Errata

This errata sheet is for MB91605A Series Hardware Manual Rev. 2 (CM71-10147-2E).

FR80
32-BIT MICROCONTROLLER
MB91605A Series
HARDWARE MANUAL

2012. 2.22

< Attached document 1-1 > Master Reception Interrupt Process

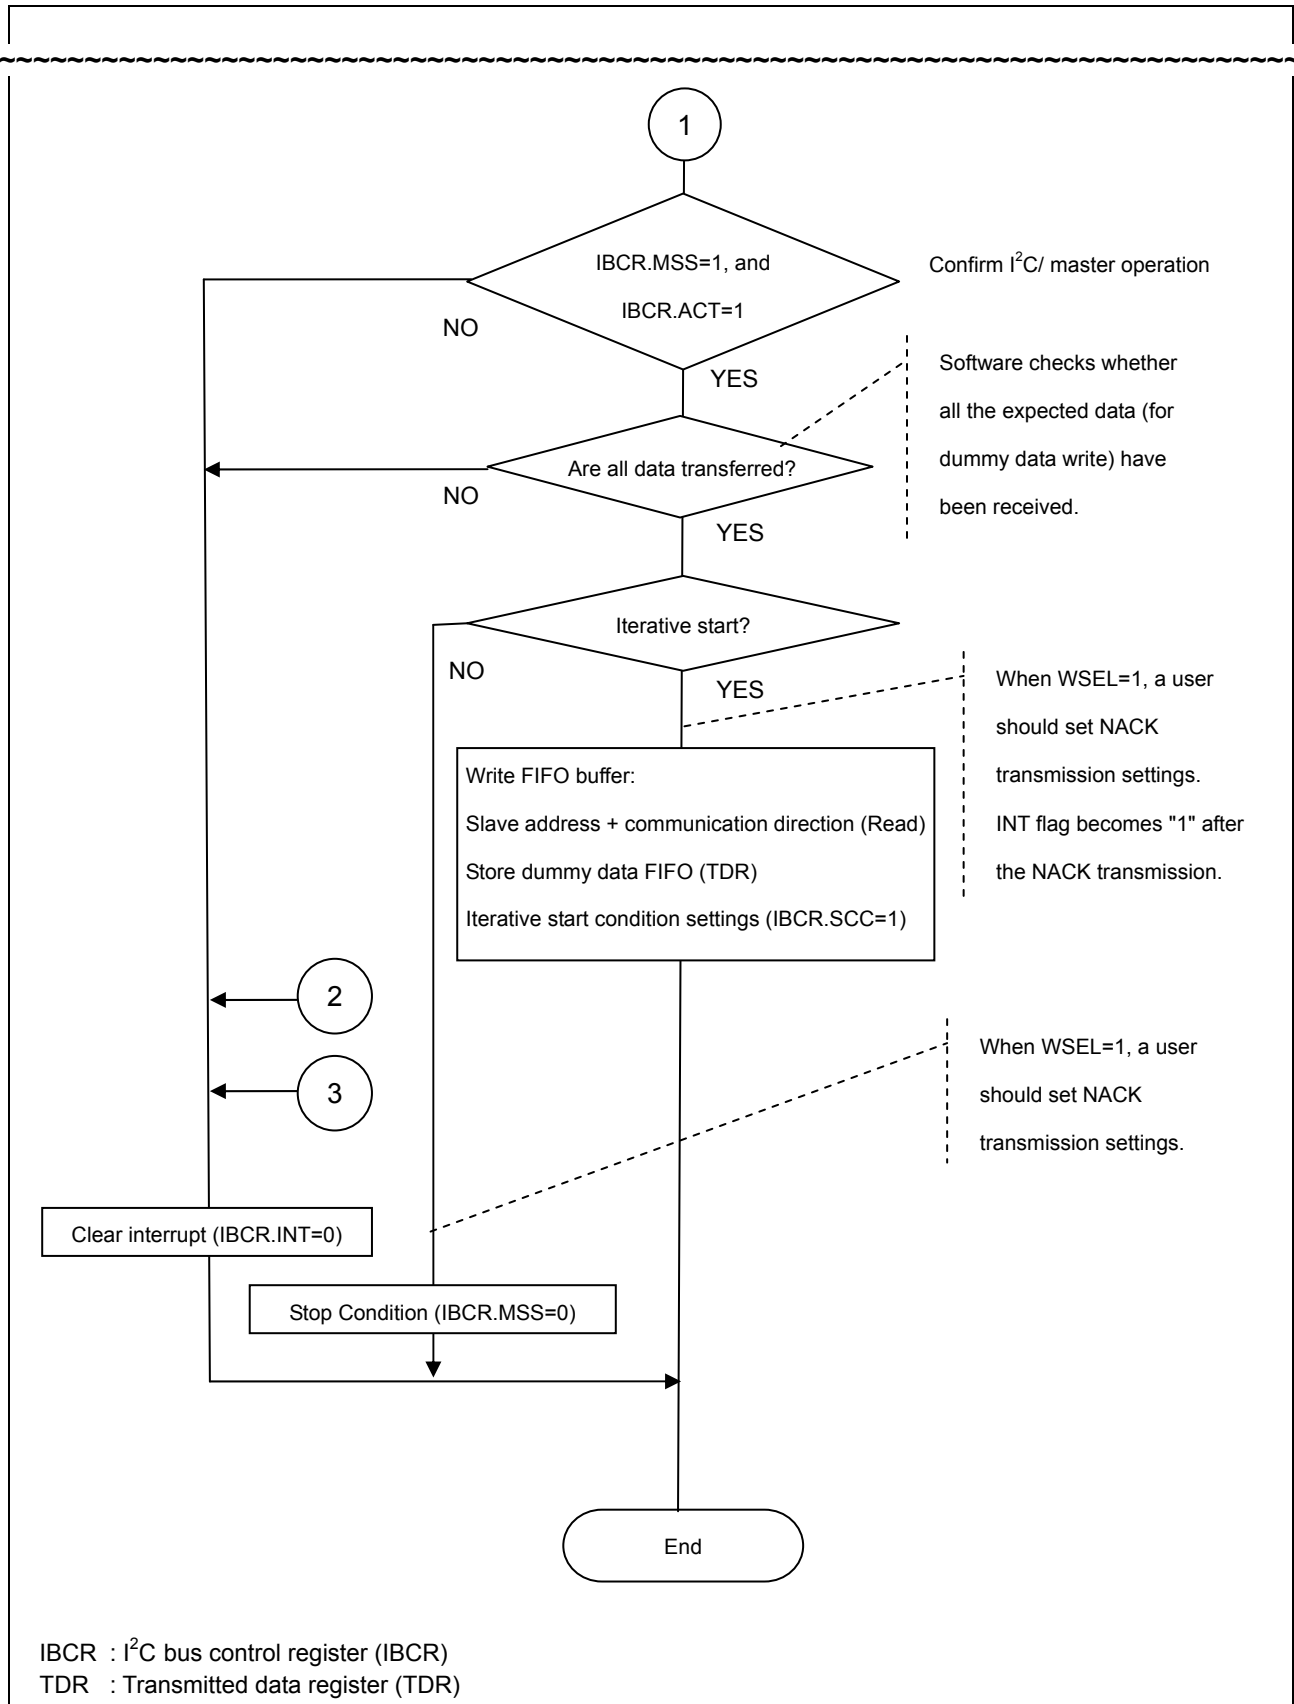
| Date | Page | Item | Description |
|----------------|-------------|---------|---|
| 2010/ 6/7 | 677, 683 | 24.23.1 | <p>The figure was corrected as < Attached document 1-1 > and < Attached document 1-2 >.</p> <p>[mcu_doc1081]</p> |
